STAFF RECOMMENDATION 917 Caruthers Avenue February 15, 2017

Application: New construction- detached accessory dwelling unit
District: Waverly-Belmont Neighborhood Conservation Zoning Overlay
Council District: 07
Map and Parcel Number: 11801026000
Applicant: John Root, rootARCH
Project Lead: Melissa Sajid, melissa.sajid@nashville.gov

Description of Project: The request is to construct a six hundred and sixteen square foot (616 sq. ft.) detached accessory dwelling unit.

ARCHITECTURAL SITE PLAN

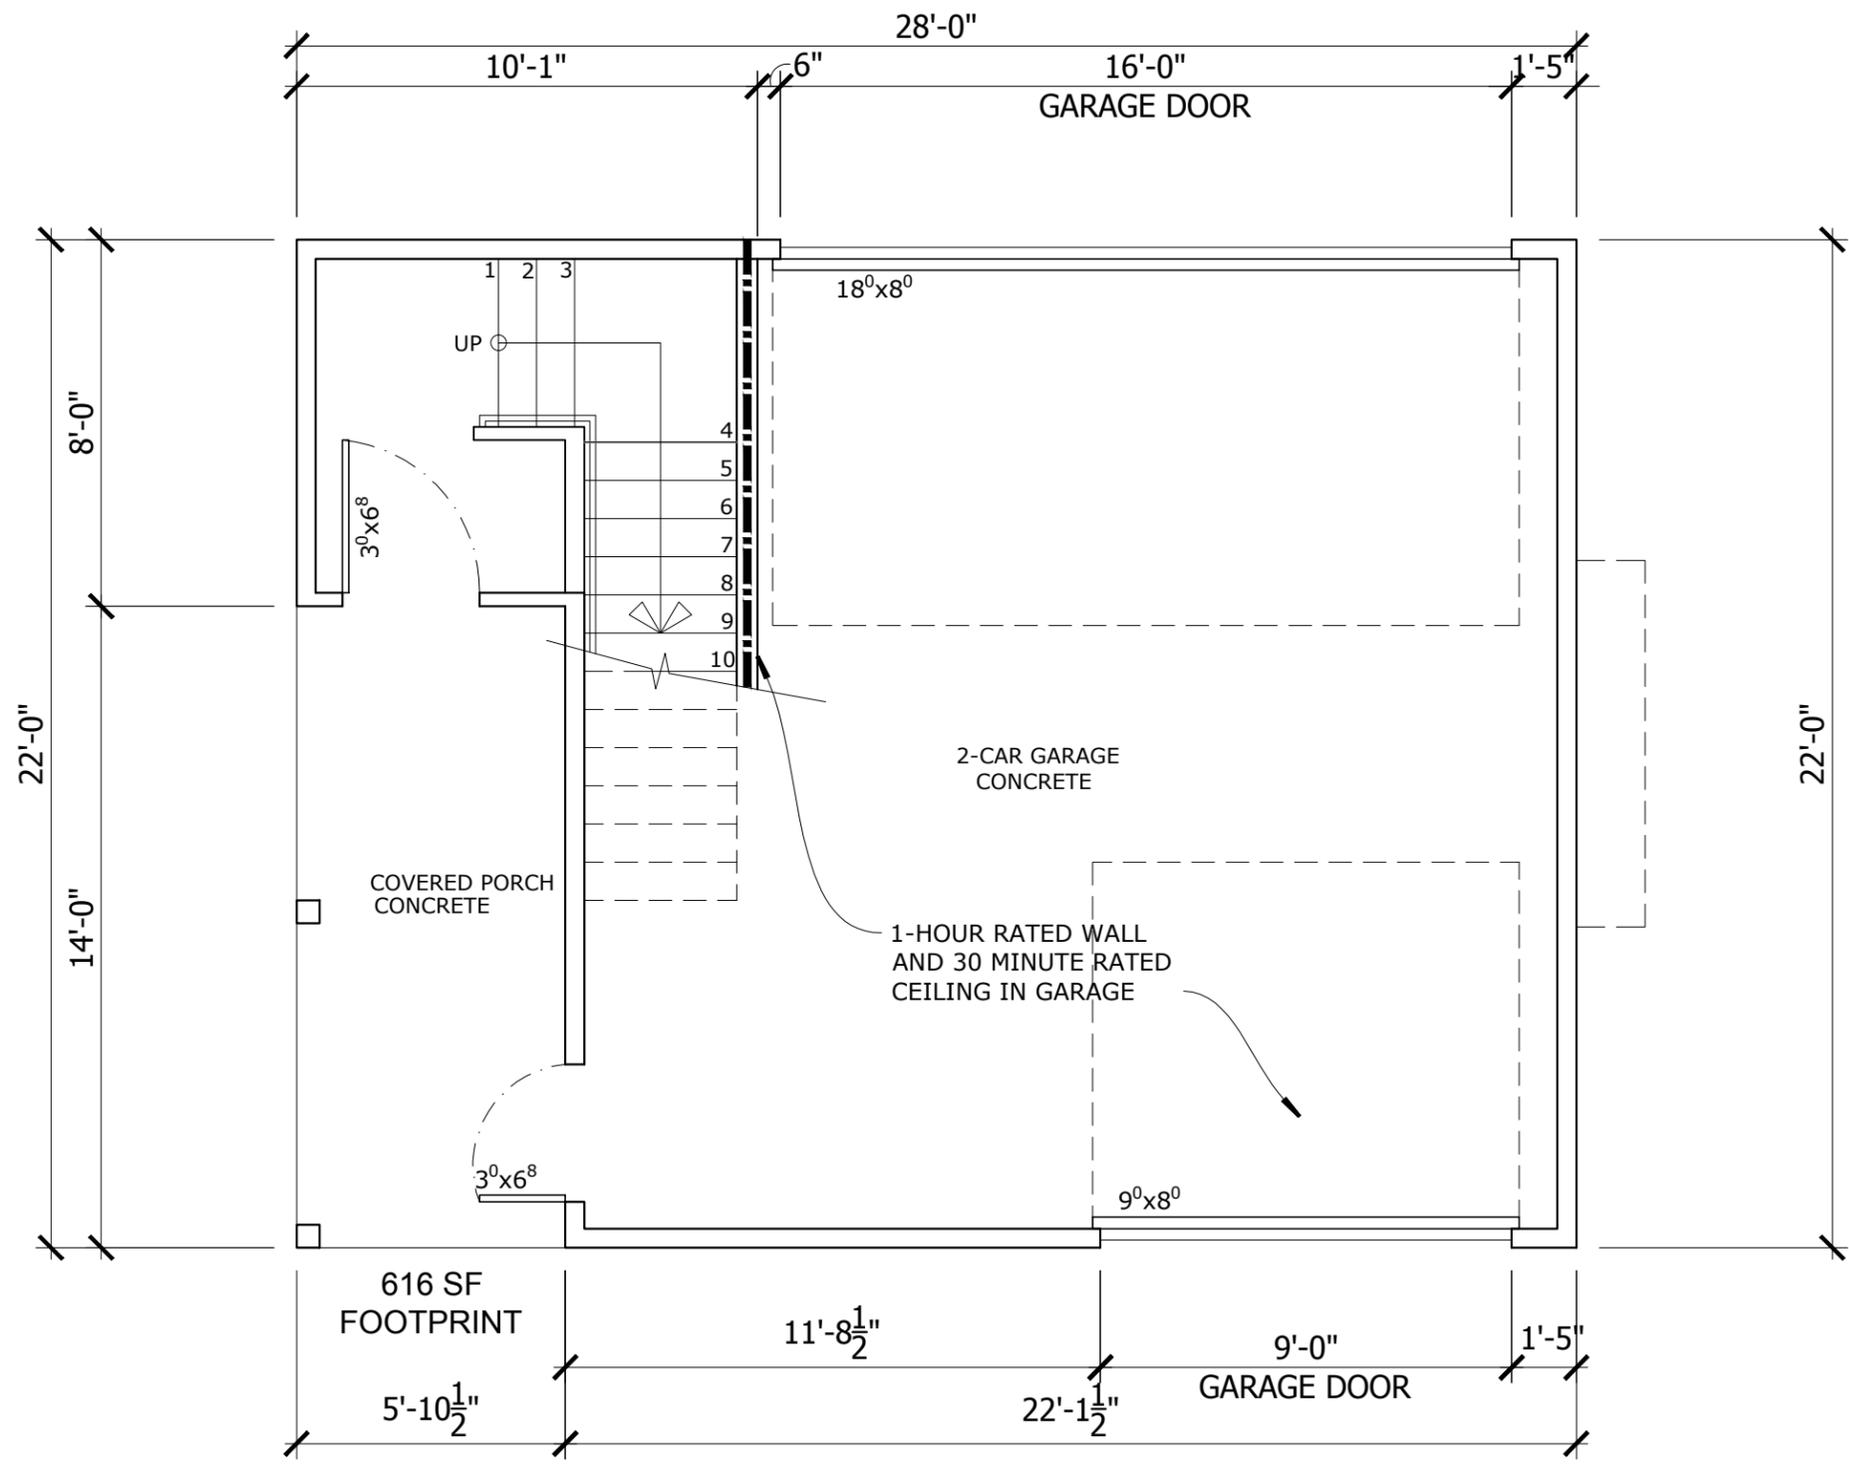
Setbacks: As proposed, the DADU meets all required setbacks per the Zoning Code. For outbuildings with a footprint less than seven hundred square feet (700 sq. ft.), the Zoning Code requires a minimum three foot (3') side setback and ten foot (10') rear setback when the garage door opens to the alley. The proposed DADU is six hundred and sixteen foot (616) footprint, including the recessed porch, and is located seven feet (7') from the right side property line, fifteen feet (15') from the left side property line, and ten feet (10') from the rear property line. The project meets Section III.H.6. of the design guidelines.

MINIMUM	PROPOSED
Space between principal building and DADU/Garage	20'	41'
Rear setback	10'	10'
L side setback	3'	15'
R side setback	3'	7'
How is the building accessed?	From the alley or existing curb cut	Alley

The project meets section III.H.6 and 7 of the design guidelines and 17.16.30.G. 4 of the ordinance.
